SUBJECT: MEETING WITH PUBLIC SERVICE ELECTRIC AND GAS COMPANY  
RELATED TO FIRE PROTECTION AT SALEM UNITS 1 AND 2

## SALEM GENERATING STATION FIRE HAZARD ANALYSIS

FIG 3.  $F_L$  vs.  $t_e$

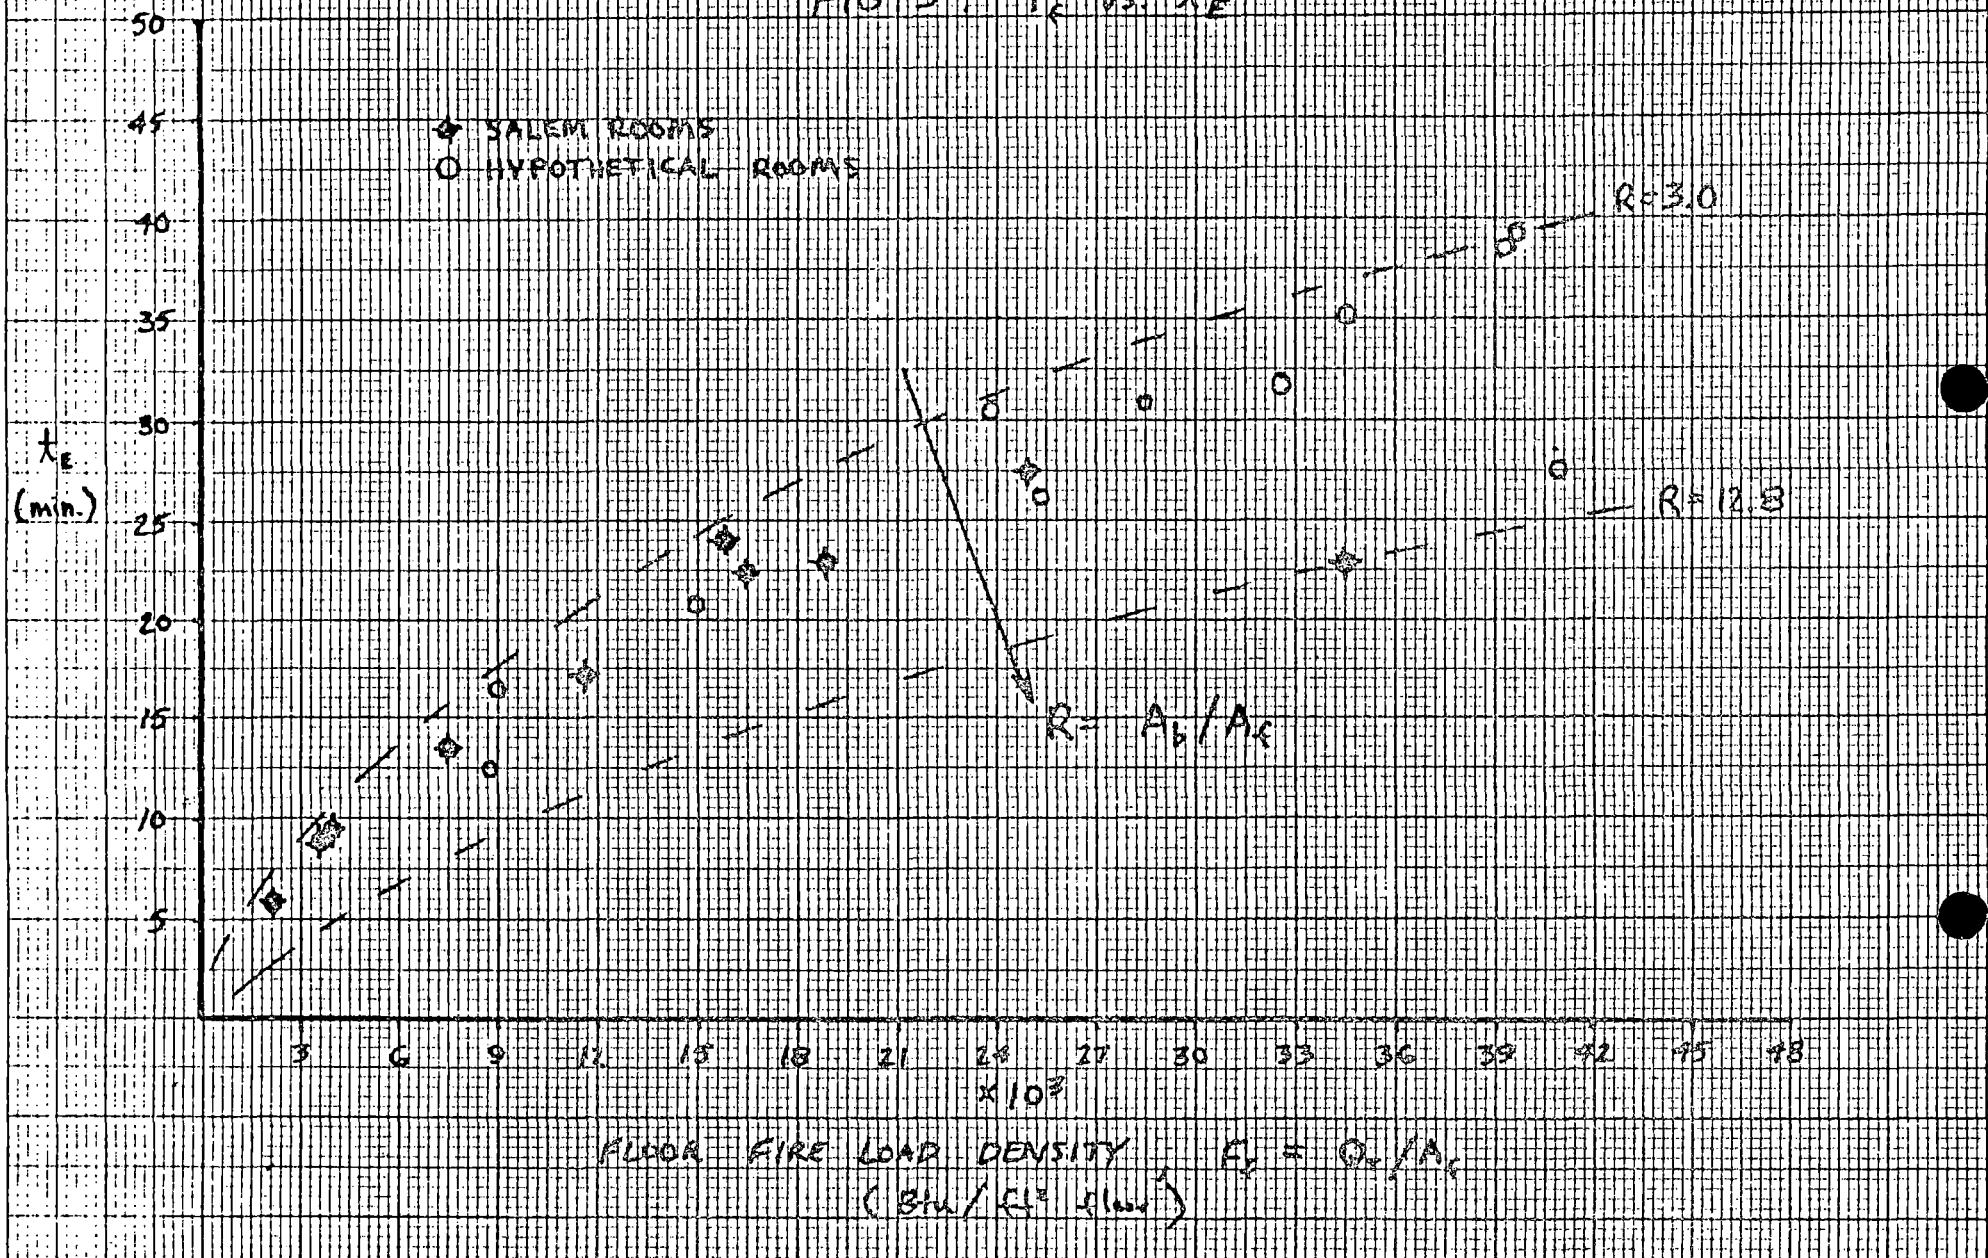
- Unsuccessful correlation of floor fire load density with equivalent E-119 fire severity, Figure 3.
- Successful correlation using the total boundary area fire load density,  $t_E = 0.168 F_b^{0.605}$ .
